Intel[®] Celeron[®] Processor Specification Update

Document Number: 243748-047

The Intel[®] Celeron[®] processor may contain design defects or errors known as errata, which may cause the product to deviate from published specifications. Current characterized errata are documented in this Specification Update.

Figure 1 Celeron® on 0.13 Micron Processor 256K Platforms Workaround

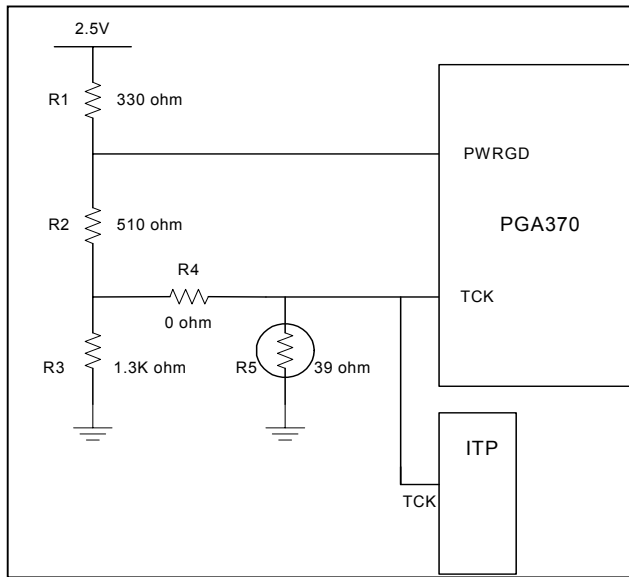
Workaround: To prevent the risk of power-on boot failures or catastrophic thermal failures, a platform workaround is required. The system must provide a rising edge on the TCK signal during the power-on sequence that meets all of the following requirements:

Please note, the example workaround circuits attached require circuit modification for ITP tools to function correctly. These modifications must remove the workaround circuitry from the platform and may cause systems to fail to boot. Review the accompanying notes with each workaround for ITP modification details. If the system fails to boot when using ITP, issuing the ITP 'Reset Target' command on failing systems will reset the system and provide a sufficient rising edge on the TCK pin to ensure proper system boot.

In addition, the example workaround circuits shown do not support production motherboard test methodologies that require the use of the processor JTAG/TAP port. Alternative workaround solutions must be found if such test capability is required.

For Production Boards:
Depopulate R5
